ADDENDUM NUMBER 2

R18-01 Island Savings Centre Lobby Washroom Upgrades

January 19, 2018

ARCHITECTUAL ADDENDUM No.2

MATCH FIXTURE STYLE TO EXISTING LOBBY LIGHTING

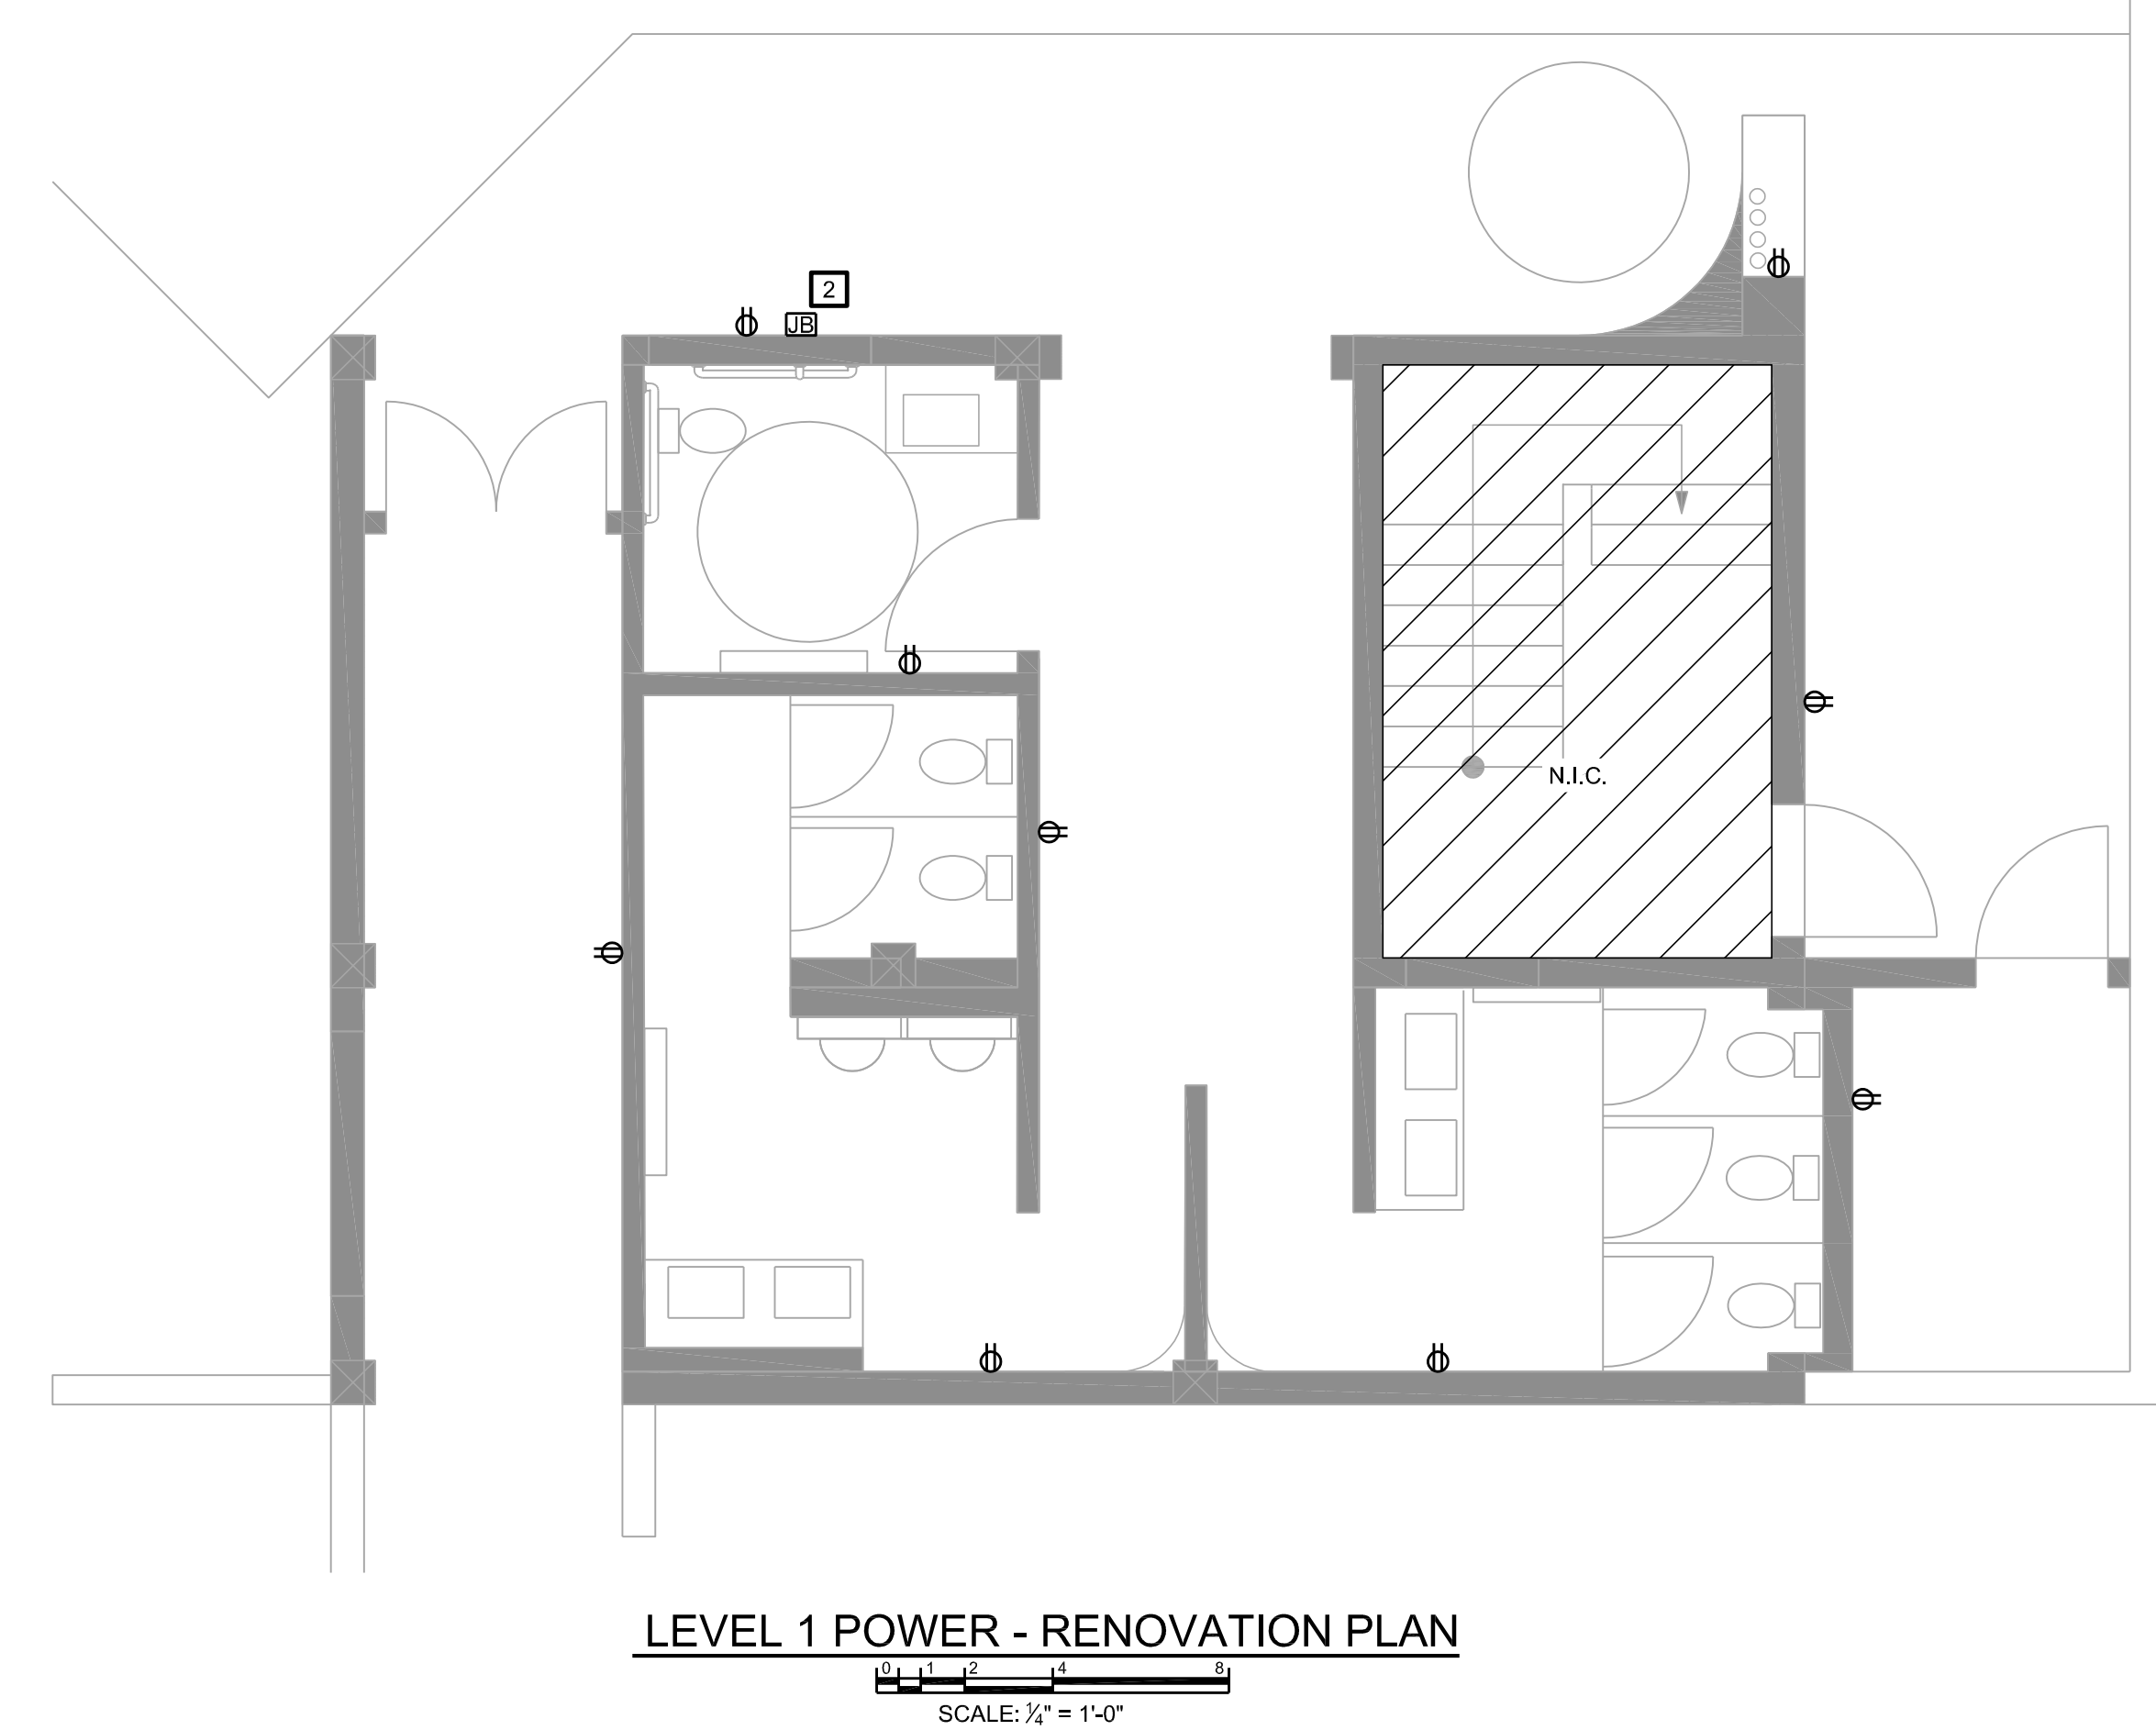
Q5. In regard to updating the fire alarm, I have a few concerns that need clarification. On drawings E0 or E1 there is nothing on either legend that identifies any fire alarm symbols that are or should be in the drawings. I have reviewed the drawings repeatedly and can't seem to find anything. Please advise.

1.1 RELOCATE and reuse existing fire alarm devices wherever possible. See attached drawing E-1

RELOCATE EXISTING FIRE ALARM DEVICES WHERE POSSIBLE
